RESPONSE TO SUBMISSIONS

EXHIBITED PHASES 2 & 3 OF LINDFIELD LEARNING VILLAGE SSD 8114

Figure 1 – Exhibited Loop Road Design

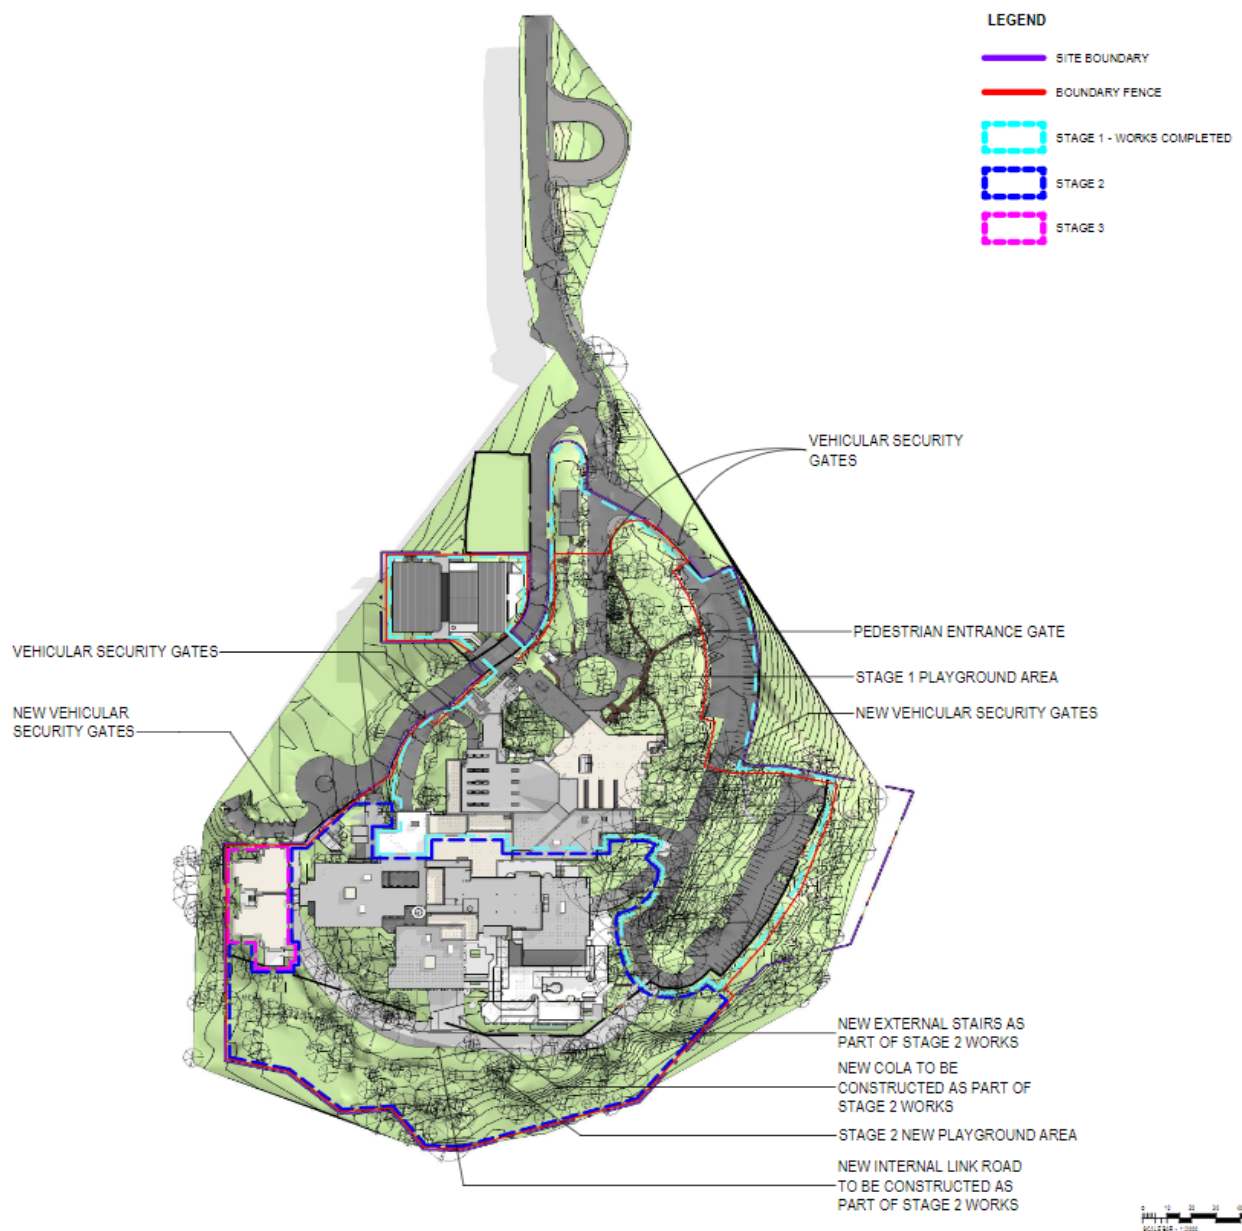
The exhibited proposal involved the construction of a loop road around the perimeter of the southern portion of the site during Phase 2(b). The loop road contained a range of set-down and pick-up zones to facilitate school drop off and pick up and provided perimeter access for firefighting purposes for most of the site. As discussed in more detail in **Section 5.2** of this RtS, the loop road is no longer proposed and revised car and bus access arrangements will be accommodated within the eastern portion of the site accessed from Eton Road. A fire trail linking the new extended driveway to Dunstan Grove is proposed for access by fire and emergency vehicles.

Figure 2 – View towards new opening from Level 4 entry showing 50% reduced size of opening

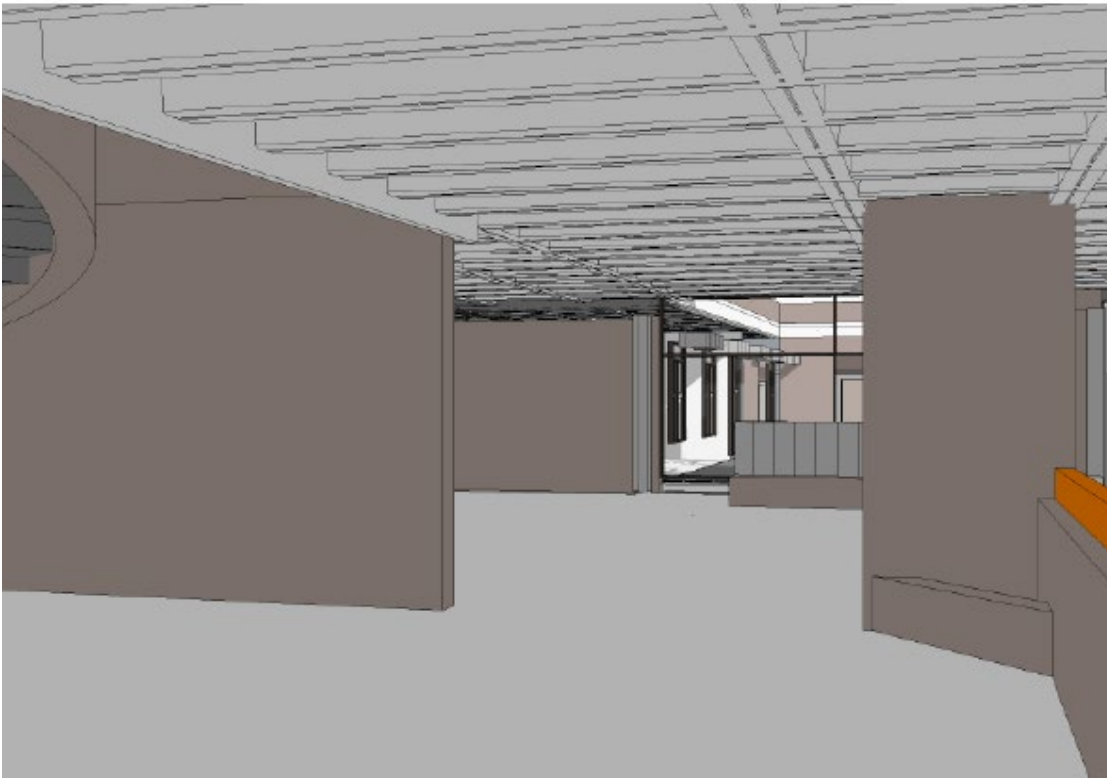
- The design of the proposed opening through the concrete wall adjacent to the spiral stairs near the Level 4 entrance to Phase 2(b) has been amended. The extent of the opening has been reduced by 50%. The area immediately adjacent to the staircase would be retained in its entirety and the opening to achieve light penetration through the building would be confined to the area to the north (refer **Figure 2**).

Figure 4 – Revised vehicle access arrangements from Eton Road

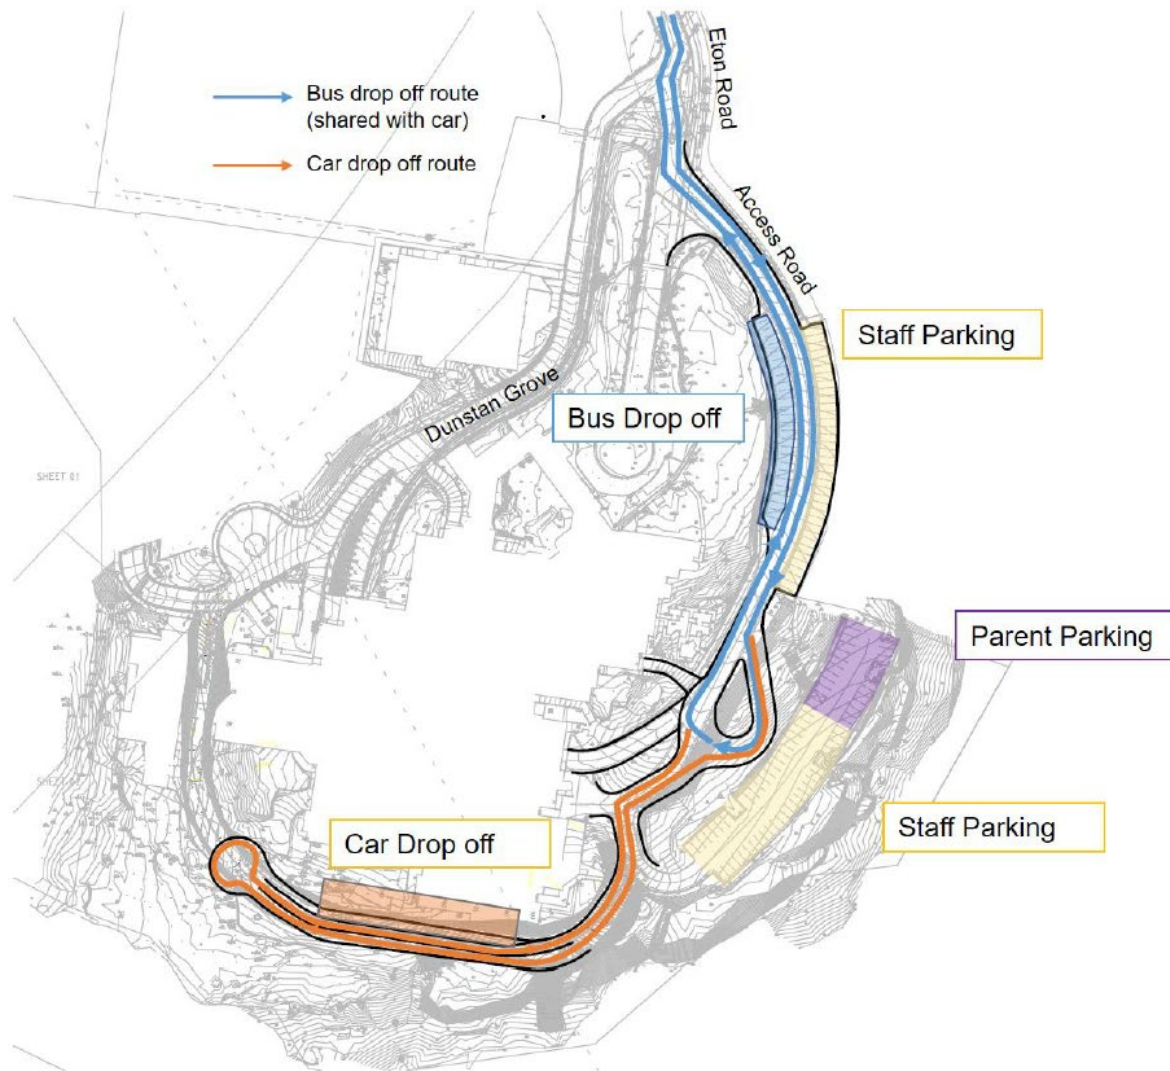
In response to the submissions received and following an options analysis for access, alternative access arrangements will utilise an extended driveway within the eastern portion of the site from Eton Road (refer **Figure 4**). The main entry driveway from Eton Road will be realigned to have priority rather than Dunstan Grove. This recognises that the main flow of traffic is for the entry and exit to the school.

The revised access design consists of expanding the existing car turnaround into a bus turnaround (30m diameter) to enable buses to use the upper car park as a bus zone. The bus turnaround would be constructed to cantilever over the topography to avoid impacts on the lower car park and has been designed for a 14.5m bus.

Figure 5 – Car DOPU area design

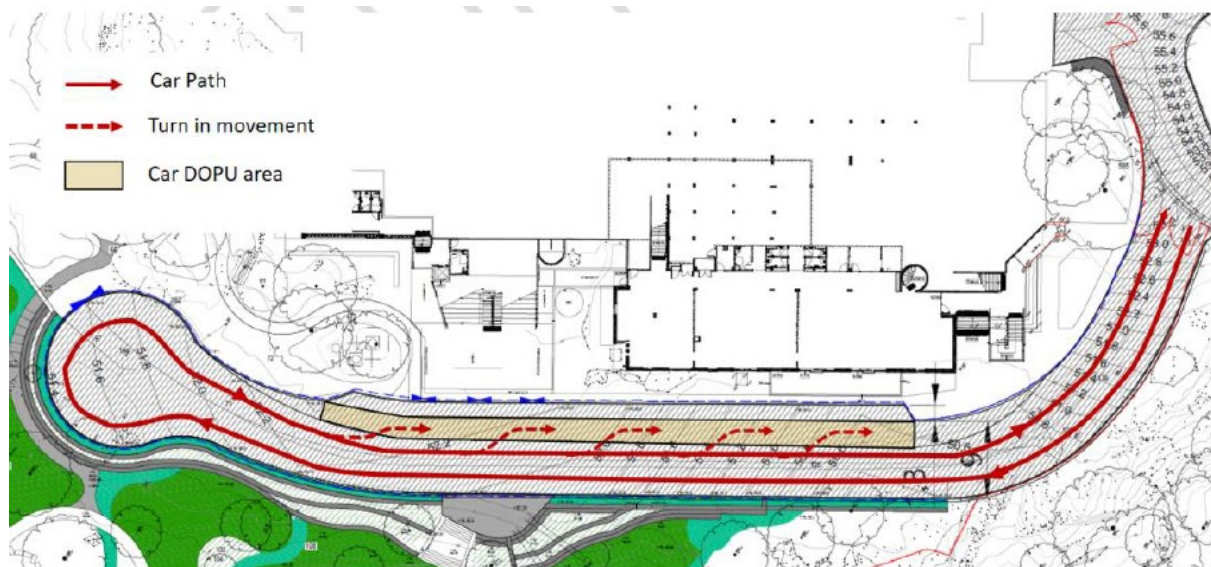
Car traffic would continue through the turnaround area to the drop off and pick up (DOPU) area to the south of the school (refer **Figure 5**). This area has space for 10 cars to operate independently with two lanes of traffic provided for passing manoeuvres.
